September 24, 2001

Mr. Alex Marion, Director
Engineering
Nuclear Energy Institute
1776 I Street, N.W., Suite 400
Washington, D.C. 20006-3708

SUBJECT: FLAW EVALUATION CRITERIA

Figure 1

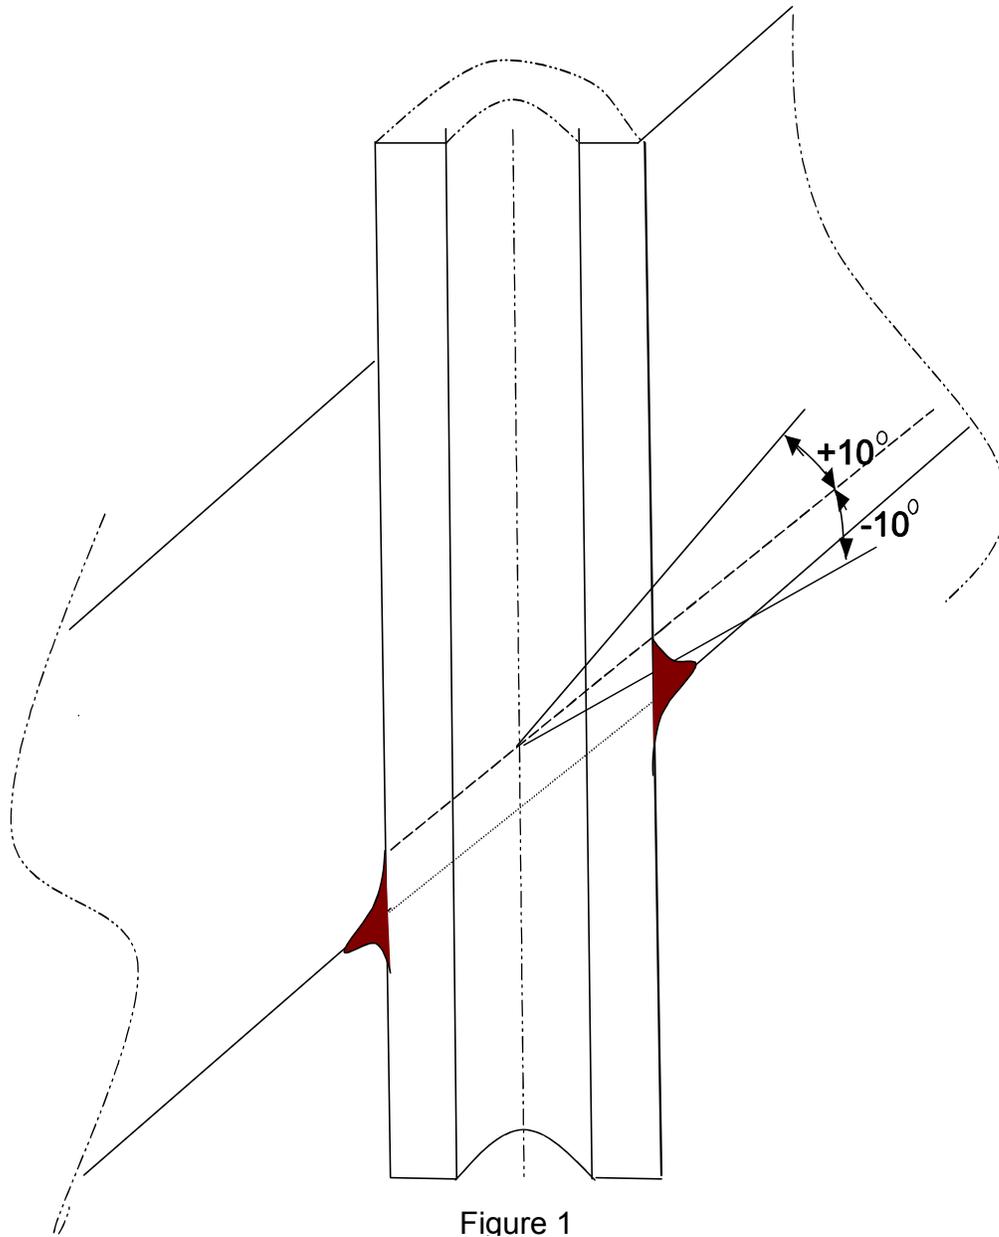
- The proximity rules of ASME Code Section XI for considering flaws as separate may be used (Figure IWA 3400-1).
- When a flaw is detected, its projections in both the axial and circumferential directions shall be determined. Note that the axial direction is always the same for each nozzle head penetration, but that the circumferential direction will be different depending on the angle of intersection of the penetration with the head. The circumferential direction of interest here is along the top of the attachment weld as illustrated in Figure 1, enclosed. It is this angle along which separation of the nozzle penetration from the head could occur.

- Flaws that are equal to or greater than 45-degrees from the vertical centerline of the CRDM nozzle, or those that are within plus or minus 10-degrees of the angle (if less than 45-degrees) that the plane of the partial-penetration attachment weld (J-groove weld) makes with the vertical centerline of the CRDM nozzle, are considered to be circumferential flaws.
